2006 - 2009 Cadillac XLR and XLR-V: Service Bulletin: #PIC4965: Creak Or Ticking Noise From Roof Behind Seats

Subject: Creak or Ticking Noise
From Roof Behind Seats

Models: 2006 - 2009 Cadillac
XLR V and Platinum
Series

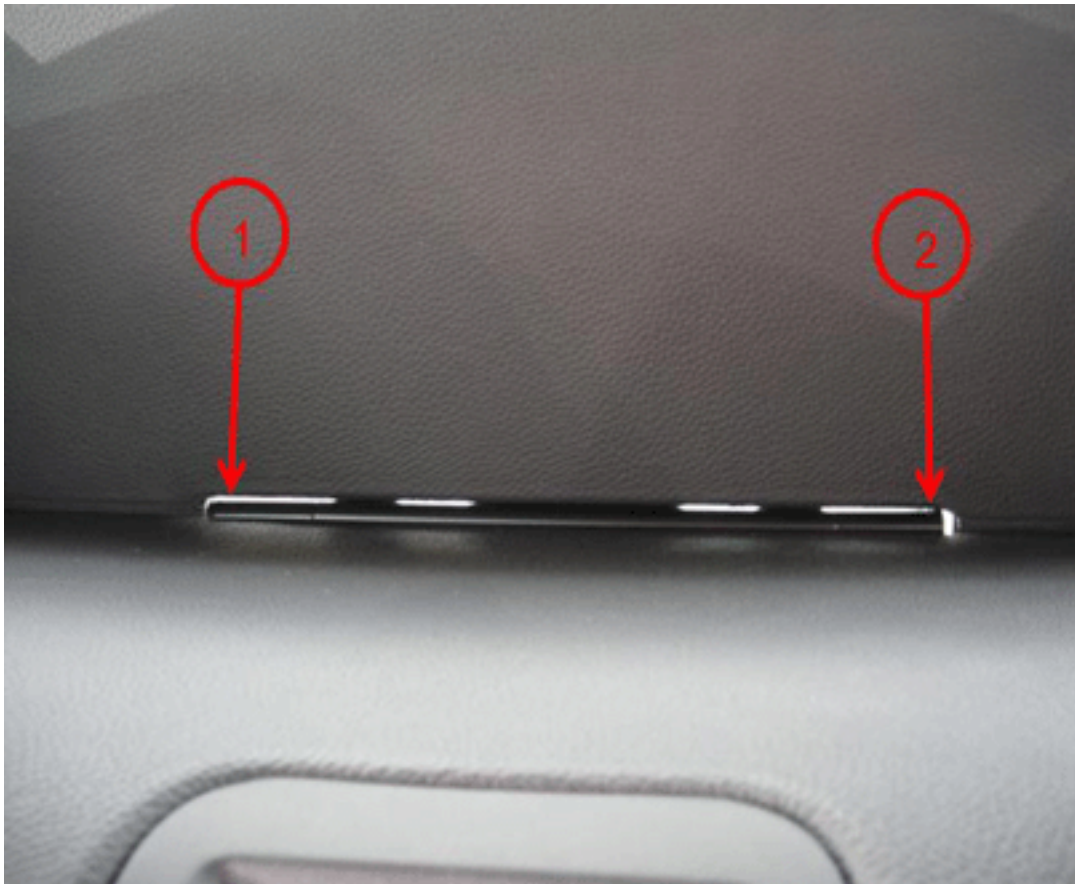
Some customers may comment on a creak or ticking noise heard behind driver while driving with slight road inputs like concrete expansion joints, or loud squawk noise when the front tonneau moves during a power folding roof cycle. This is due to a slip stick condition between the front tonneau cover center panel and the outer portions of the attached hinge. Refer to number 2 in the illustration above.

Note: When the tonneau is not adjusted correctly, the contact could occur in call out number 1 or 2 below. However only call out number 2

below demonstrates contact.

To correct this concern, first loosen the middle fastener of the center front tonneau panel hinge. Then loosen the right fastener and move the panel enough to gain 1mm of clearance between the panel and the right outer hinge barrel and re-tighten it to hold that position. Loosen the left fastener and move the panel to gain 1mm clearance between the panel and the left outer hinge barrel and re-tighten the fastener. Tighten the center fastener. When adjusted correctly, the gap for both call outs in the illustration above should look like the gap called out as number 1. Once adjusted, road test or cycle the roof system to verify the repair.
